NO: SW - 125	PRODUCT: A6ER – DIP Switch
DATE: March 2019	TYPE: Discontinuation – Streamline Product Offering

A6ER DIP Switch - Discontinuation

A6ER-□101 and A6ER-□104 Details of Applicable Models:

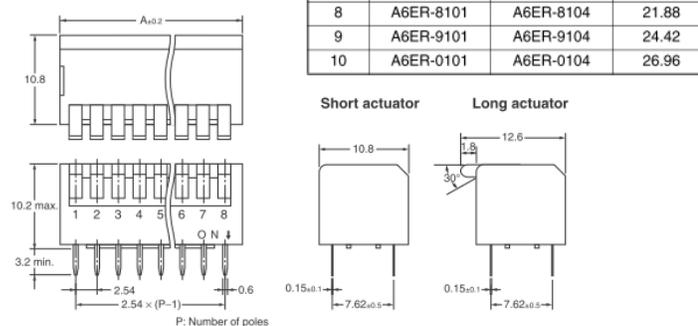
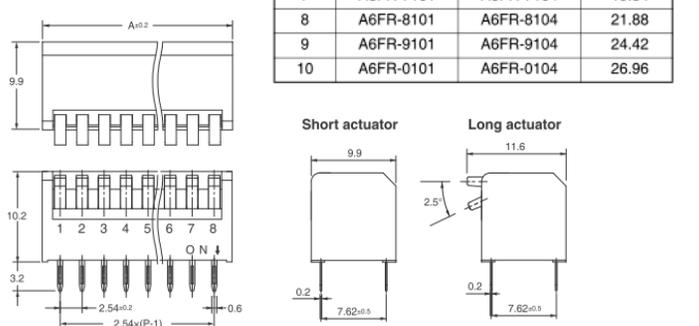
In an effort to streamline our product offering and focus on popular models of Omron’s line of DIP Switch, OMRON will discontinue the A6ER DIP Switch model series in February 2020. The suggested replacement will be our A6FR model series, which despite differences in color and dimensions, can be considered to be a functional equivalent. Please carefully read through this notification and note the differences. The following details will fully explain the discontinuation and suggested replacement considerations; should you have any additional questions, however, please communicate with the Switch Product Manager.

A6ER Suggested Replacement -- Differences from discontinued product:

Suggested replacement Model	Body Color	Dimen -sions	Wire connection	Mounting Dimensions	Charact -eristics	Operation ratings	Operation methods
A6FR-□101 Series	--	*	**	**	**	**	**
A6FR-□104 Series	--	*	**	**	**	**	**

Discontinued Product	Suggested Replacement
A6ER-0101	A6FR-0101
A6ER-2101	A6FR-2101
A6ER-3101	A6FR-3101
A6ER-4101	A6FR-4101
A6ER-5101	A6FR-5101
A6ER-6101	A6FR-6101
A6ER-7101	A6FR-7101
A6ER-8101	A6FR-8101
A6ER-9101	A6FR-9101

Discontinued Product	Suggested Replacement
A6ER-0104	A6FR-0104
A6ER-2104	A6FR-2104
A6ER-3104	A6FR-3104
A6ER-4104	A6FR-4104
A6ER-5104	A6FR-5104
A6ER-6104	A6FR-6104
A6ER-7104	A6FR-7104
A6ER-8104	A6FR-8104
A6ER-9104	A6FR-9104
